# West Cambridge Development

## MASTER PLAN REVIEW

APRIL 2004

Forming an Amendment to:

2004 Master Plan Review  
Figure 100 rev A

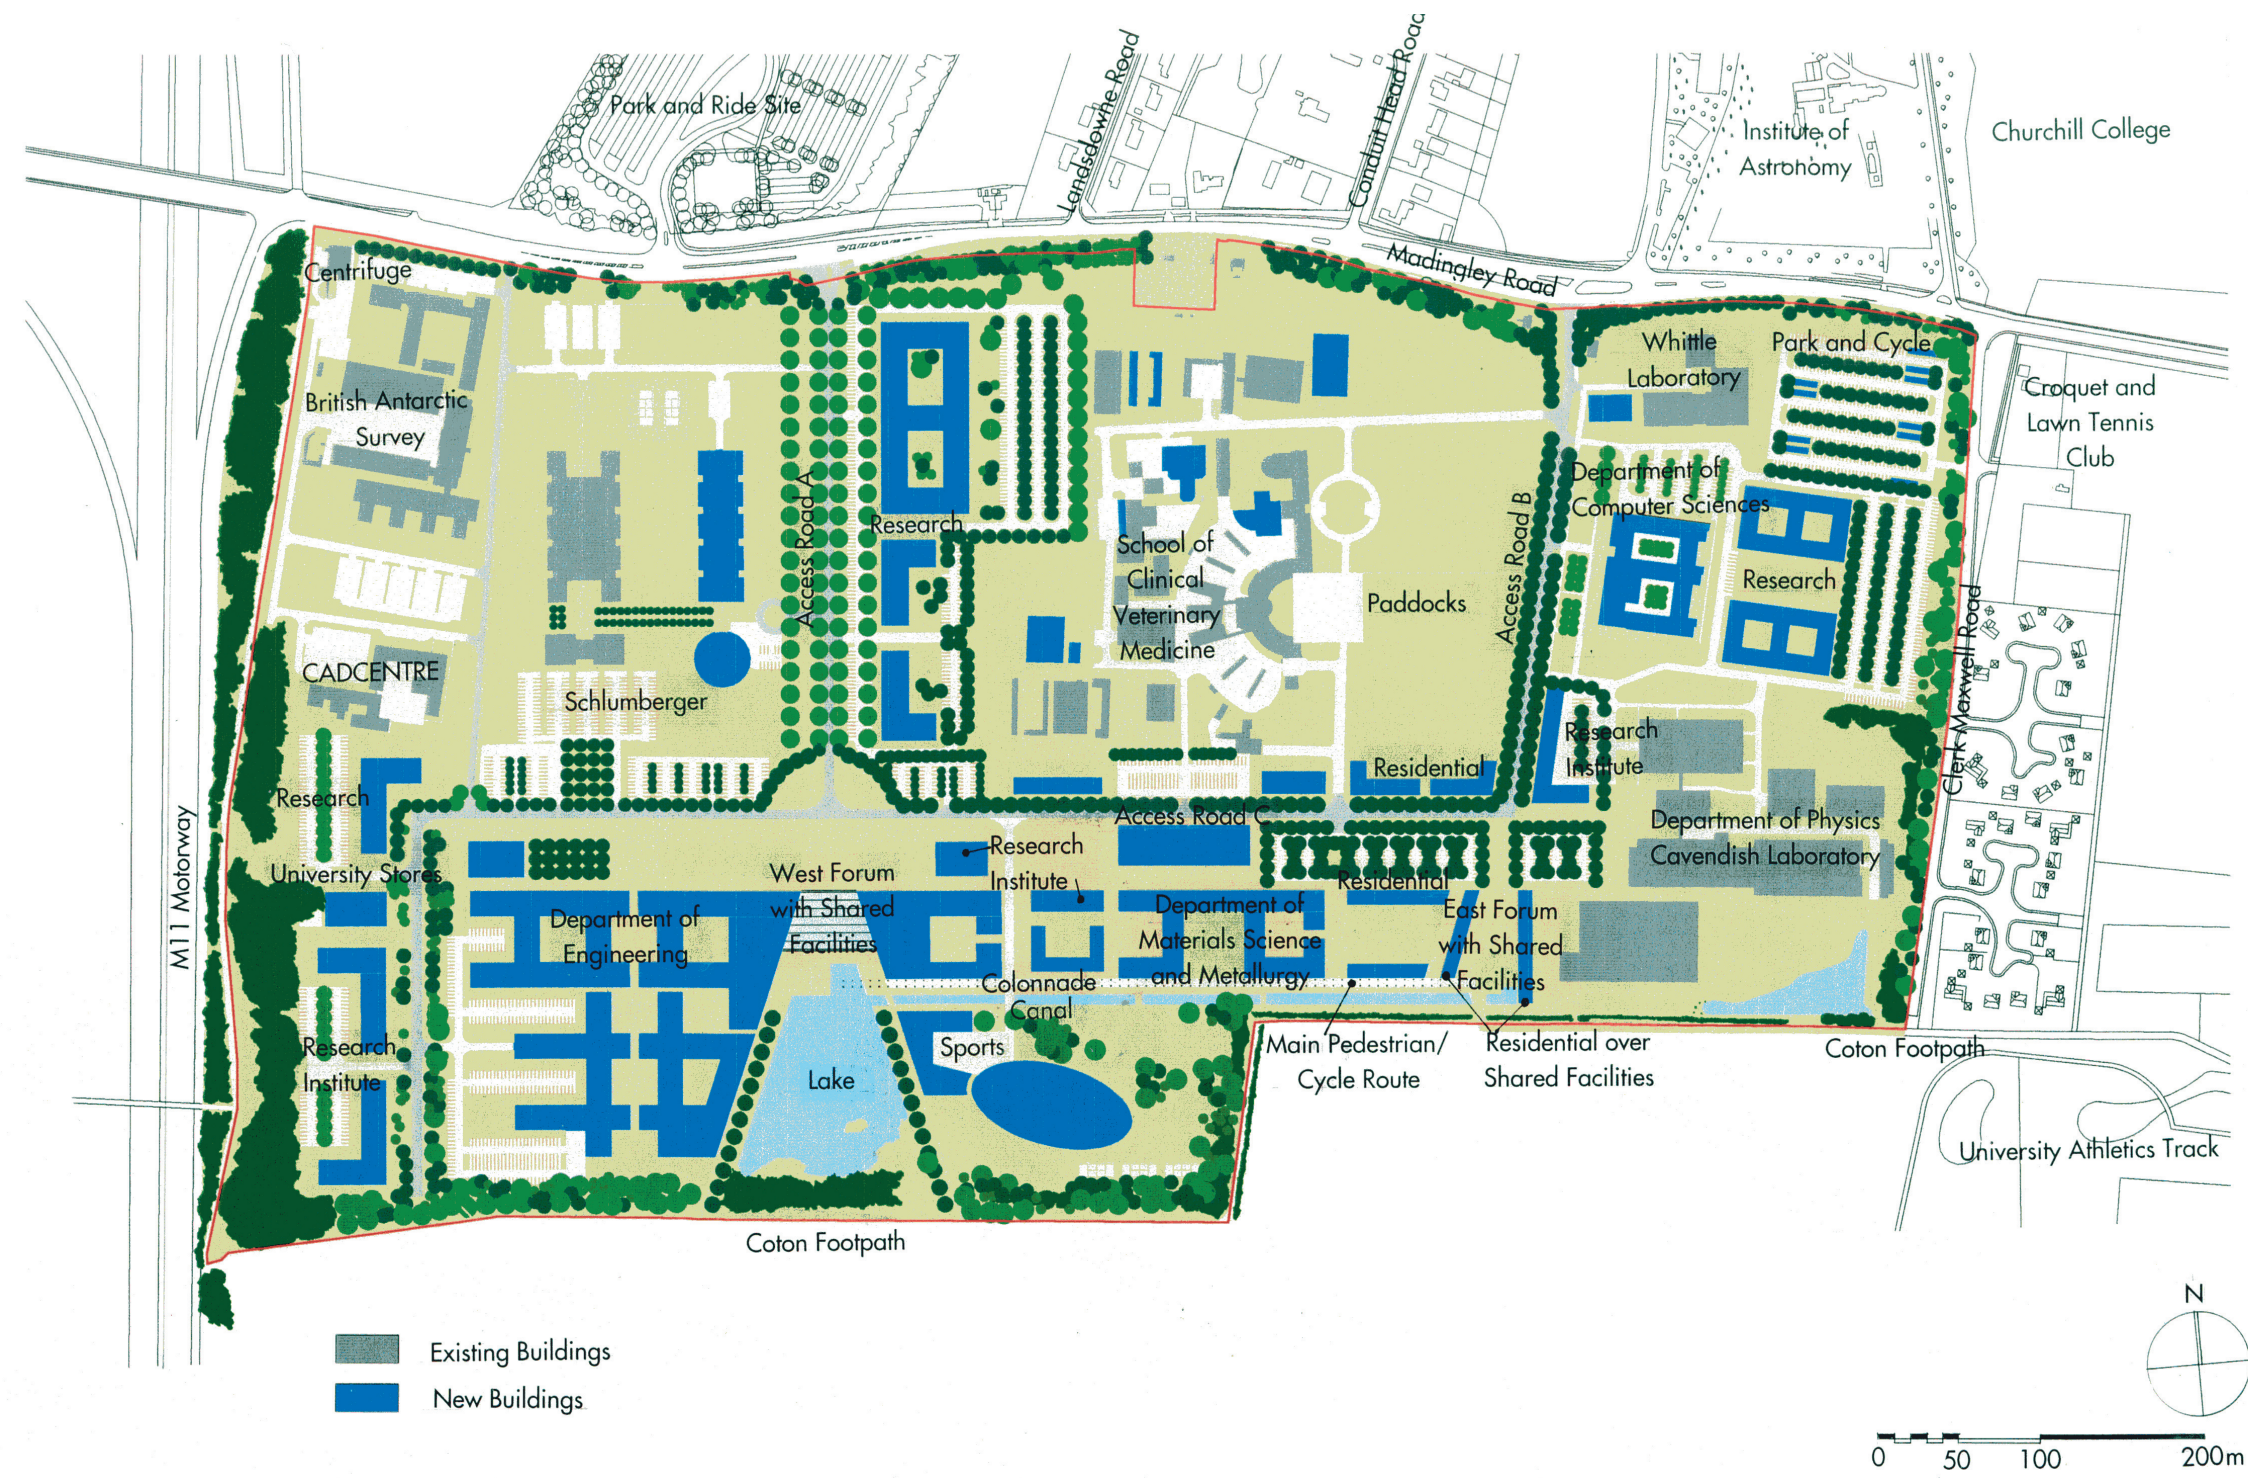
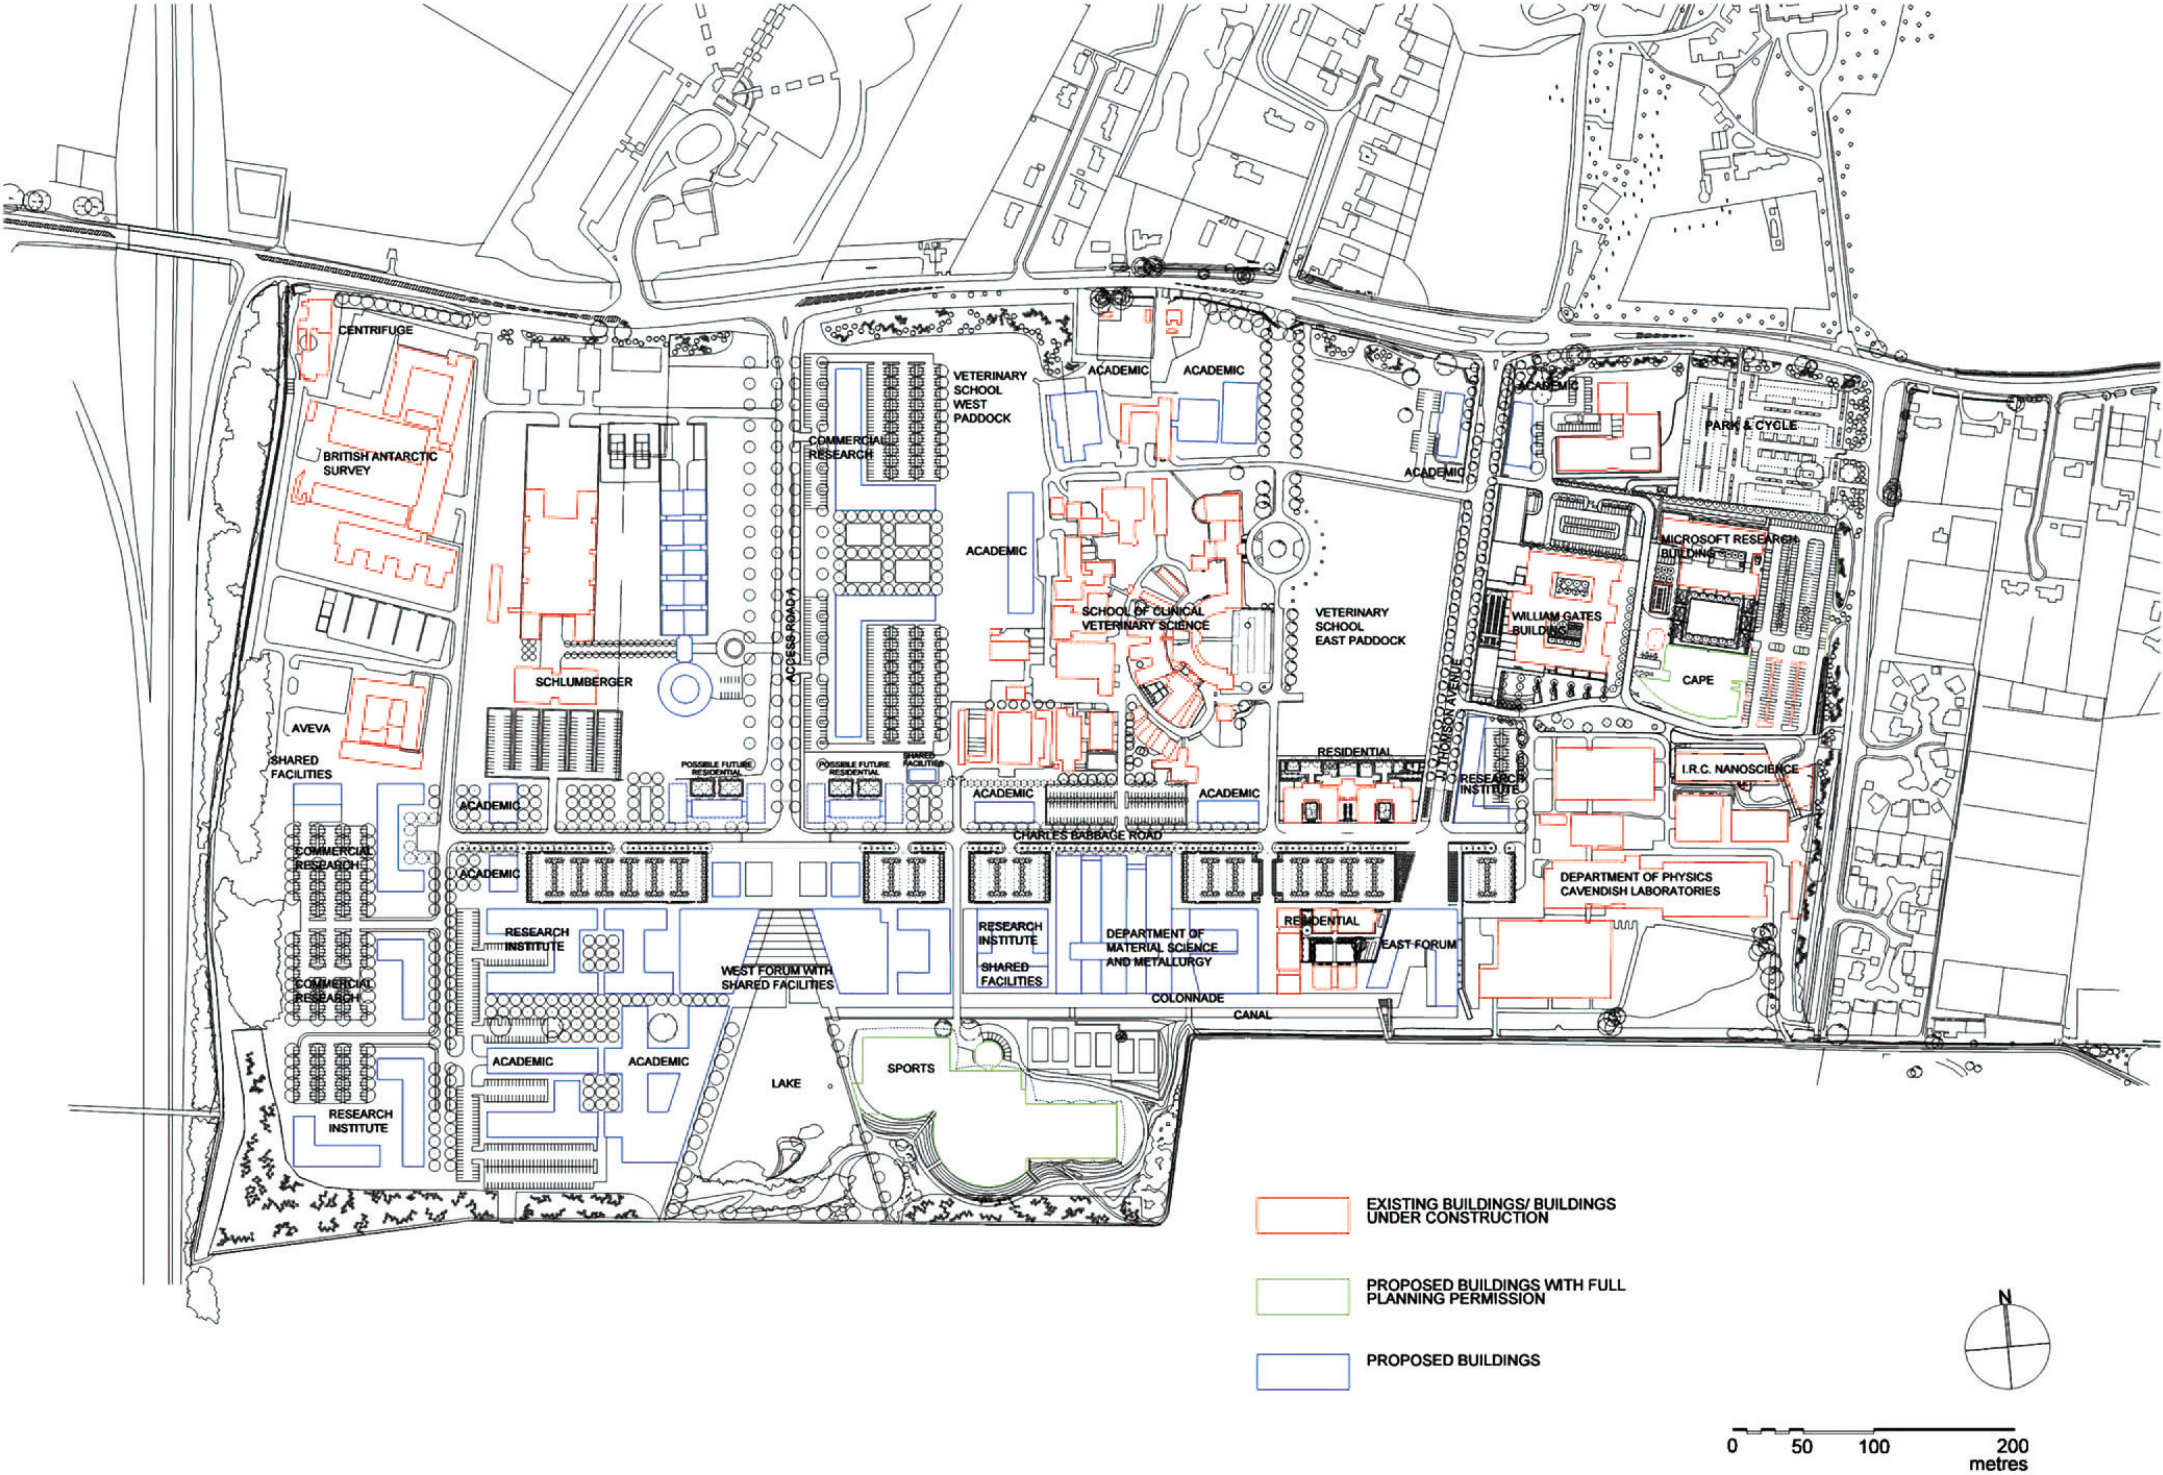
A number of projects have received Full Planning Approvals since 1999, which supersede the Outline Planning Approval. Some include minor amendments to the Master Plan. The 2004 Master Plan Review includes these amendments, to avoid discrepancies between the Master Plan Outline Planning Approval and the Full Planning Approvals for individual sites. The amendments are listed below:

1.2 South East area of Plot C (known as Centre for Advanced Photonics and Electronics or CAPE): Ref C/01/0526  
(Figure 101 rev A, key number 14)

1.3 Sports Complex, Plot B: Ref C/01/1229/FP  
(Figure 101 rev A, key number 15)

1.4 Residences and Nursery, Plot A2 and Part D: Ref C/02/0257  
(Figure 101 rev A, key number 17 and Figure 49 rev A)

1.5 Other Approved Developments  
(Figure 101 rev A, key number 16)

2.1 East Forum, Plot A2  
(Figure 101 rev A, key number 1 and Figure 6 rev A)
